**LUDLUM MEASUREMENTS, INC.**

Re: USNRC License no. 42-21454-01E

Subject: Response to your letter dated 03 June 2014 requesting additional information concerning license amendment request, the following is submitted

Attachment 2

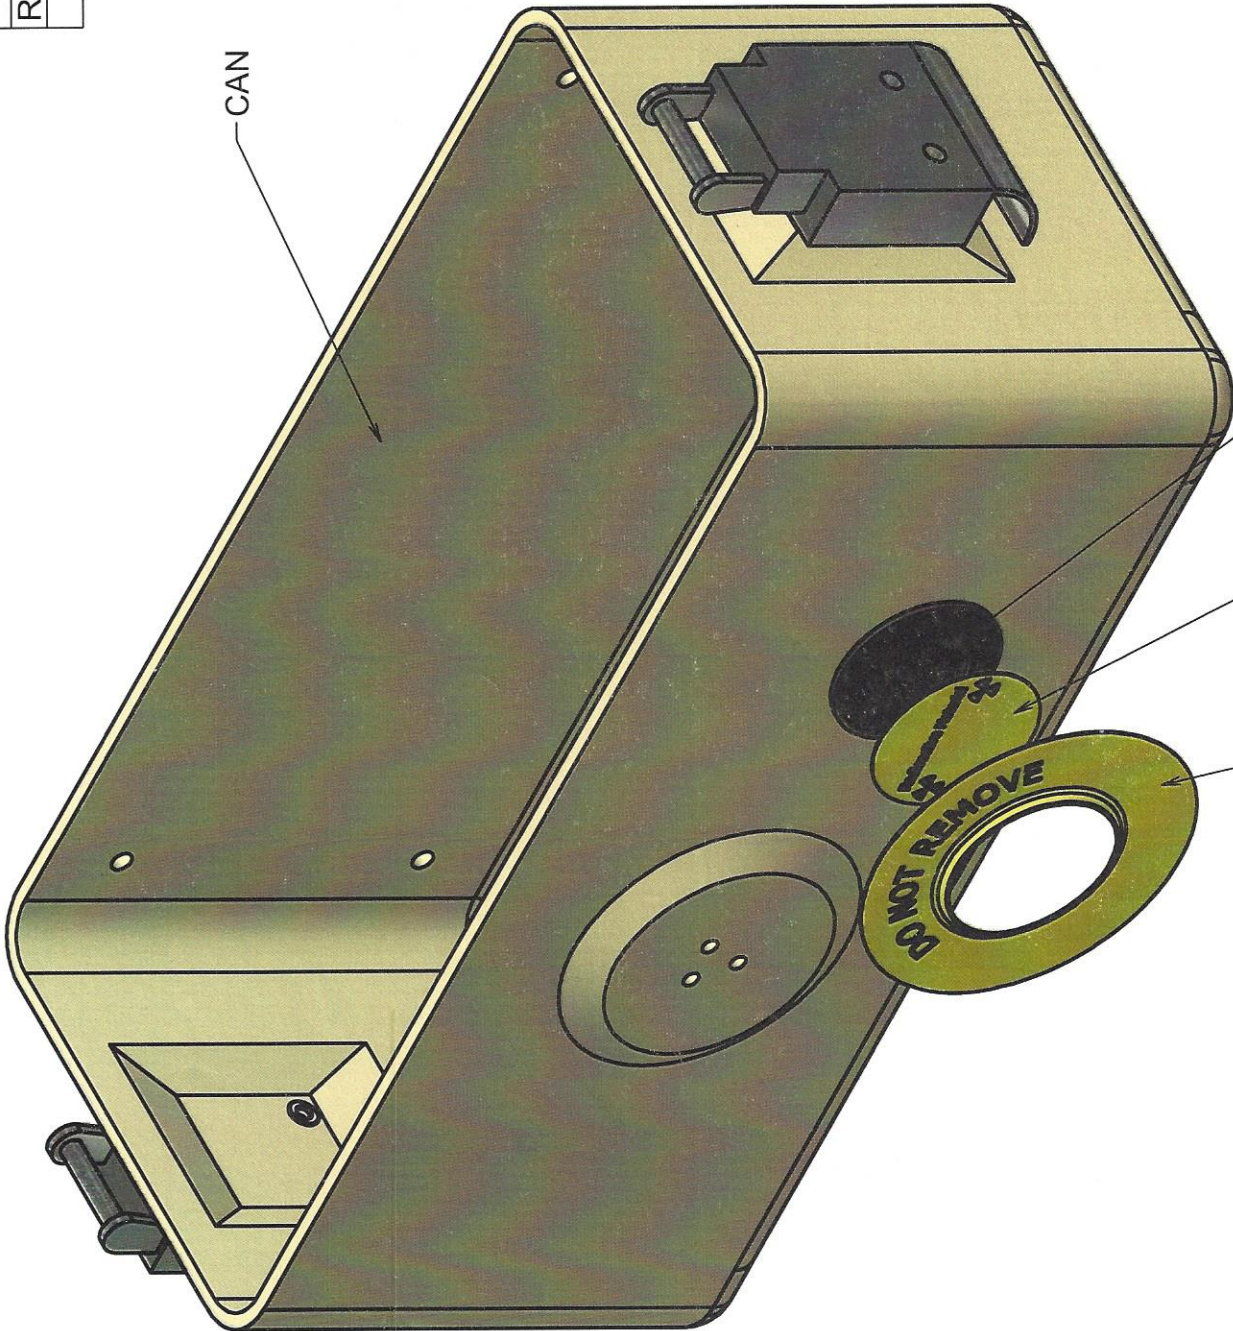
- 2.a. When utilizing the LMI part number 7464-474 as part of the assembly to attach a check source to an instrument, the USNRC approved label as supplied with the check source from the manufacturer is in view due to this part has a clear center as shown in **ATTACHMENT 2**.

Attachment 3

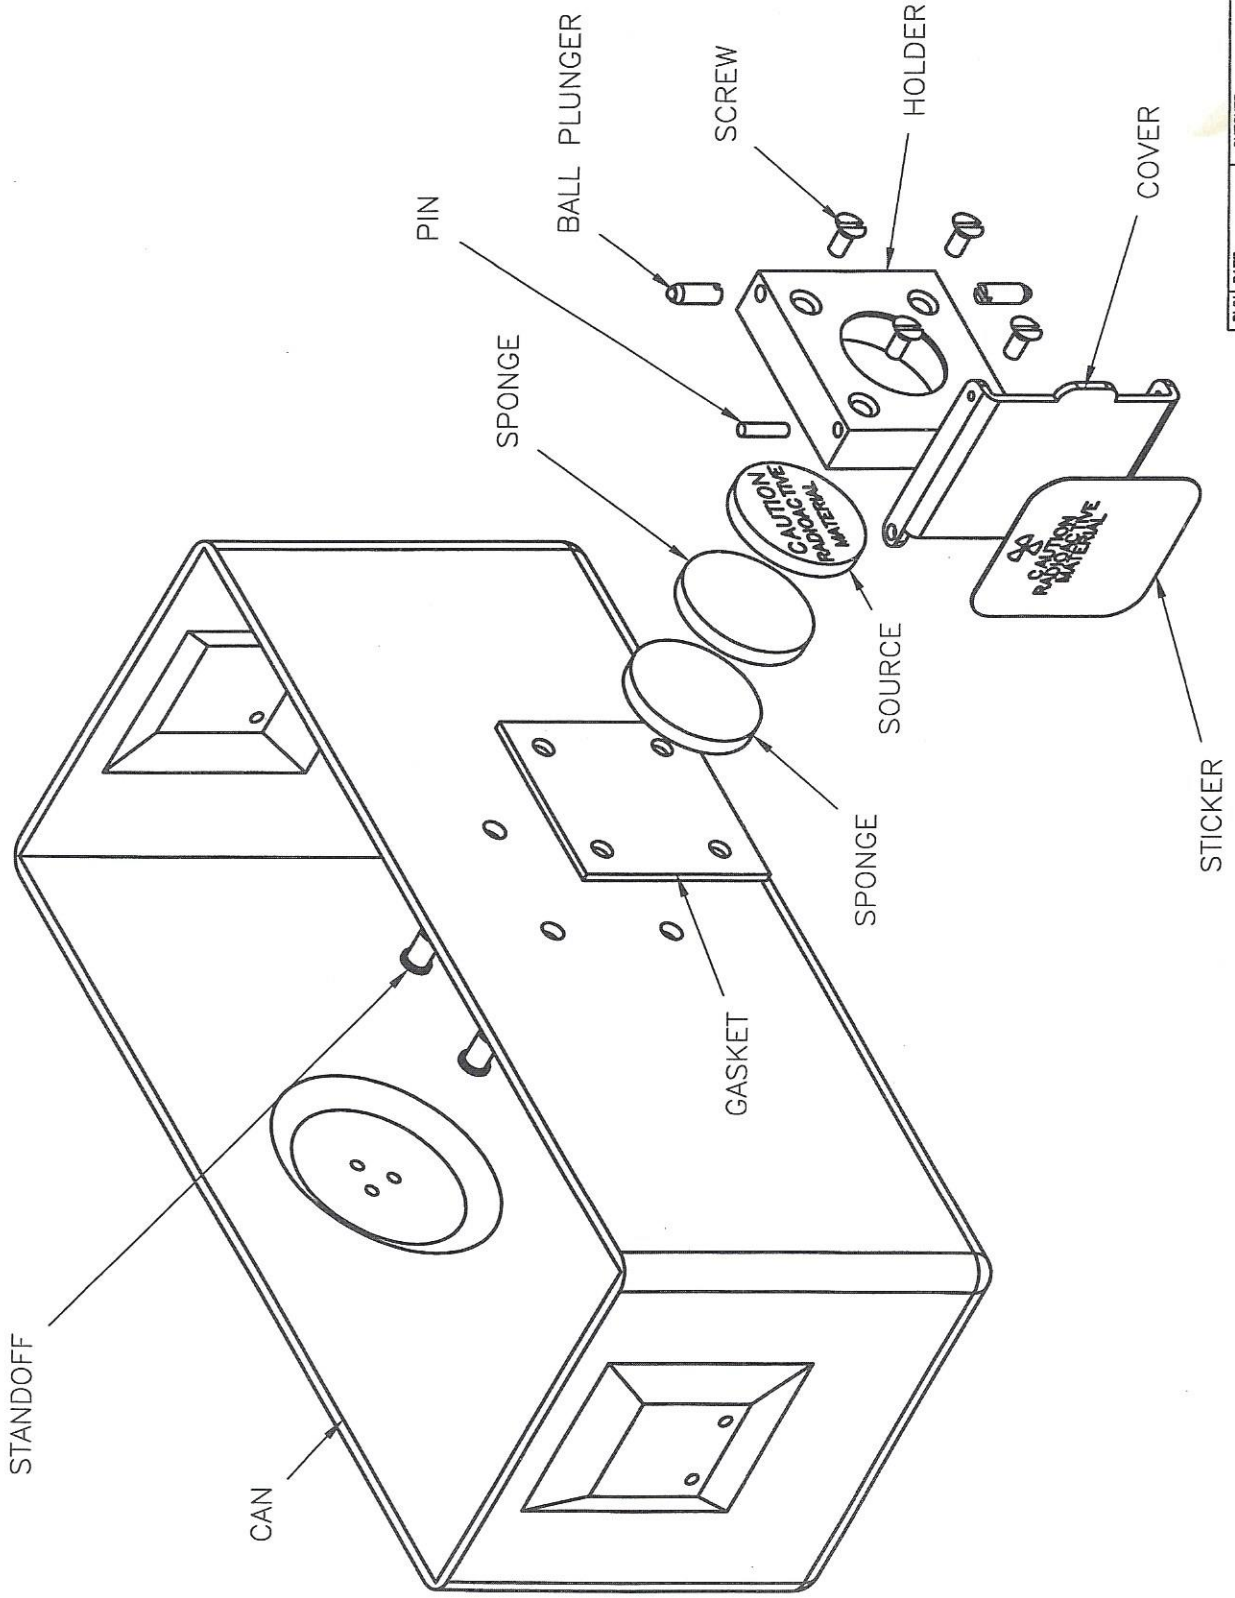
- b. When attaching a check source utilizing the mechanical assembly, the portion of the assembly labeled "holder" on the drawing labeled as **ATTACHMENT 3** is milled to have an opening to view the USNRC approved label as supplied with the check source from the manufacturer.
